**ADVISORY BOARD ON  
RADIATION AND WORKER HEALTH**  
*National Institute of Occupational Safety and Health*

**Review of NIOSH Site Profile  
for  
*Savannah River Site***

**SCA-TR-TASK1-0003**

March 21, 2005

**Figure 5.2 Variation of the Backscatter Factor with the Quality of the Radiation for a Number of Field Sizes**  
(Source: Hine and Brownell 1956)

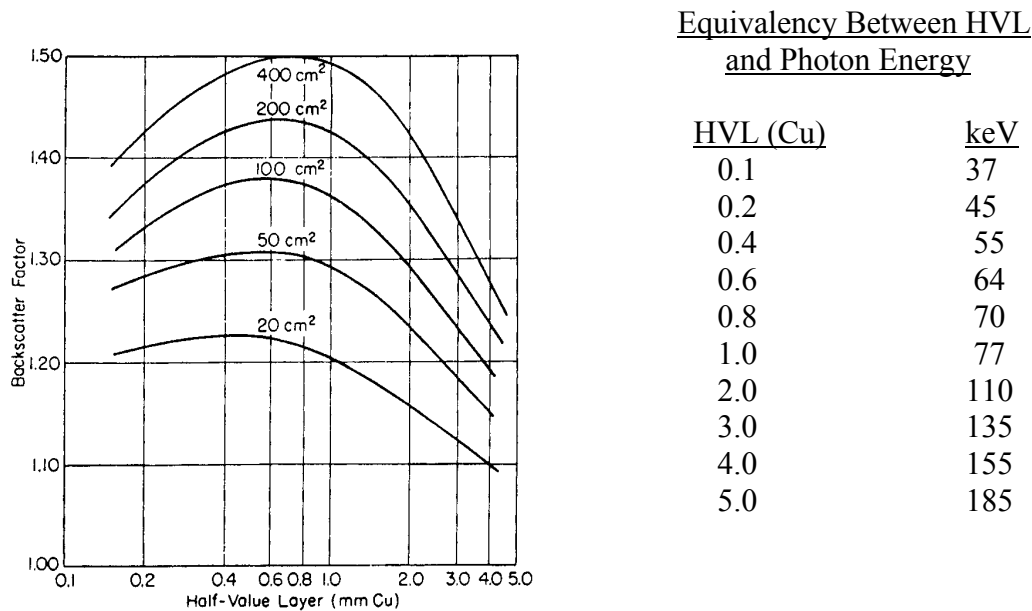
From data presented in Figure 5.2, it is likely that the cited on-phantom correction factor of 1.119 may be too low for photon energies between 30 and 250 keV.

**Figure 5.3 Trends in SRS and Hanford Collective Neutron Dose Normalized to Plutonium Production**

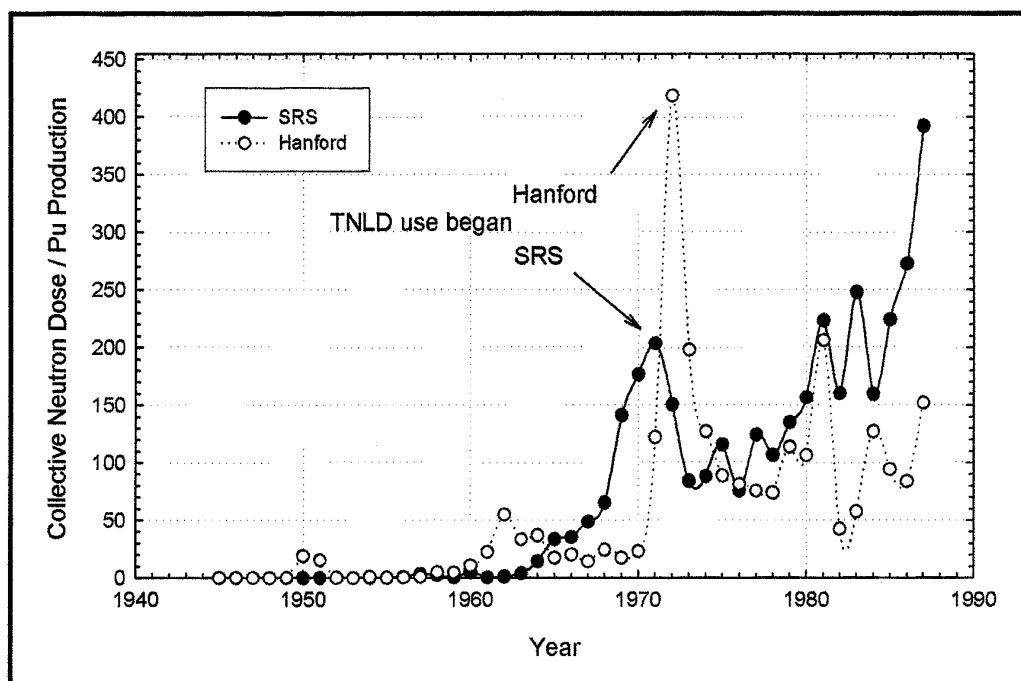
The above referenced Figure 5.3.4.2-2 is reproduced below as Figure 5.3. Neither statement (as emphasized above) is supported by data shown in Figure 5.3:

- At both SRS and Hanford, the rise in collective dose (supposedly standardized to plutonium production) began well before the advent of the TLND; and, in both cases, the standardized collective dose dropped precipitously after the implementation of the TLND with subsequent fluctuations.
- Because the collective neutron doses were **standardized** (i.e., defined in person-rem per unit quantity of Pu), the observed oscillations clearly indicate that the collective dose is **not** correlated with or linked to plutonium production, but may very well be the result of variations in neutron fields that surround work conditions in a given area and the variable response of the TLND.
